## **THE WHEELER BUILDING SUBDIVISION**

Engineering Comments: FINAL PLAT COMMENTS (should be addressed prior to submitting the FINAL PLAT for review and/or signature by the City Engineer):

APPLICATION NUMBER 5 DATE January 4, 2018

# DETAIL SITE PLAN

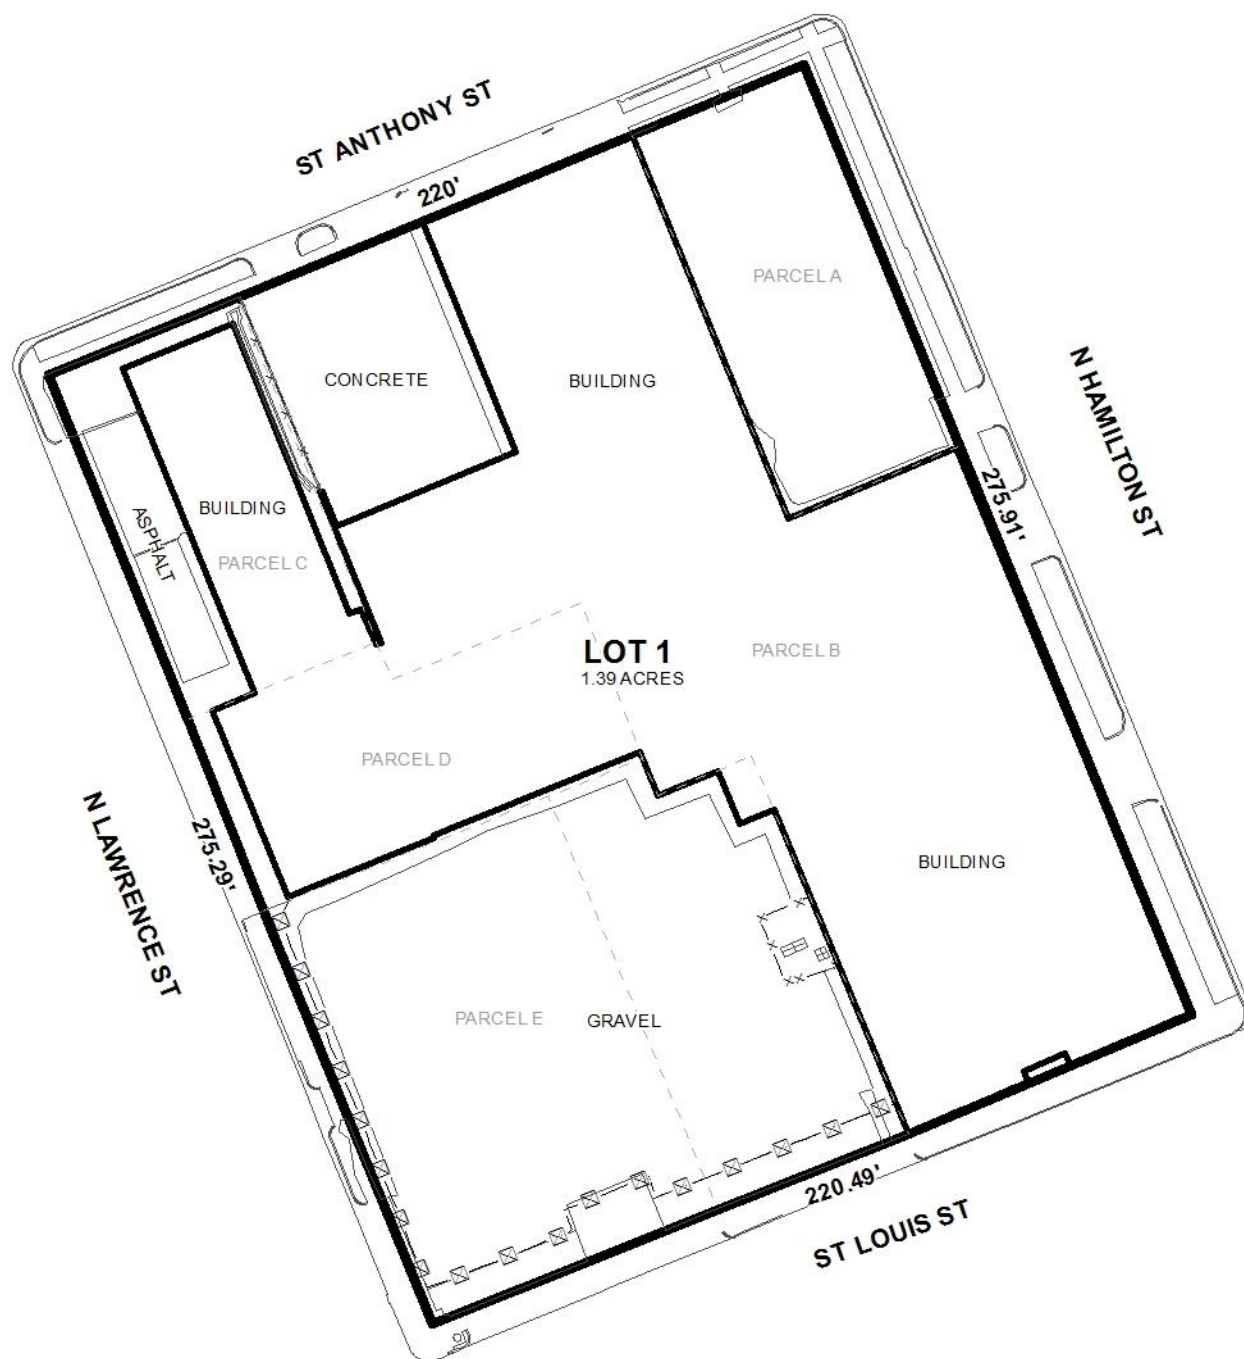
For lots within the SD-WH Sub District of the Downtown Development District there exists a maximum 10’ building setback along their primary street frontage. Such a setback applies to new construction along the primary frontage, and the site is developed in compliance with this requirement, thus no additional setbacks are required; however, the setback maximum should be depicted, if approved.

The proposed lot exceeds the minimum size requirement for lots served by public water and sanitary sewer systems, and is appropriately labeled in square feet and acres on the preliminary plat. This information should be retained on the Final Plat, if approved; or, provision of a table providing the same information of the Final Plat may suffice.

Per requirements of the DDD regarding access management, the site should limited to one (1) curb cut per street frontage; however, Google Street View images depict existing curb cuts, as follows: one (1) curb cut on St. Louis Street, three (3) curb cuts on North Lawrence Street, four (4) curb cuts on St. Anthony Street, and three (3) curb cuts on North Hamilton Street, for 11 total curb cuts. Recent review of a Land Disturbance Permit for the site shows that the amount of curb cuts is proposed to be reduced to six (6) via the removal of the curb cut to St. Louis Street, the removal of two (2) curb cuts from St. Anthony Street, and the removal of the curb cuts from North Hamilton Street; and, one (1) additional curb cut would be added along North Lawrence Street. Nonetheless, if the applicant wishes to maintain the additional curb cuts, Variance approval by the Board of Zoning Adjustment will be required prior to the issuance of any Land Disturbance or Building Permits. If the subdivision application is approved, a note should be placed on the Final Plat stating the site is limited to one (1) curb cut per street frontage, or as approved by the Board of Zoning Adjustment, with any changes to their sizes, locations, or designs to be approved by Traffic Engineering and conform to AASHTO standards.

In a pre-development meeting regarding the re-development of the property, Staff received preliminary drawings illustrating changes to the interior and exterior of the existing building, as well as changes to parking on the site. It should be noted that such changes must comply with the frontage requirements of Section 64-3.I.15, and with the parking lot screening requirements of Section 64-3.I.11(b)(3) of the Zoning Ordinance. Review of compliance with these standards

Based on the preceding, with a waiver of Section V.D.6 of the Subdivision Regulations, this application is recommended for Tentative Approval subject to the following conditions:

- 1) retention of the lot sizes in square feet and acres on the Final Plat, or the furnishing of a table on the Final Plat providing the same information;

- 2) placement of a note on the Final Plat stating the lot is limited to one (1) curb cut per street frontage, with any changes in their sizes, locations, or designs to be approved by Traffic Engineering and conform to AASHTO standards, or as approved by the Board of Zoning Adjustment;
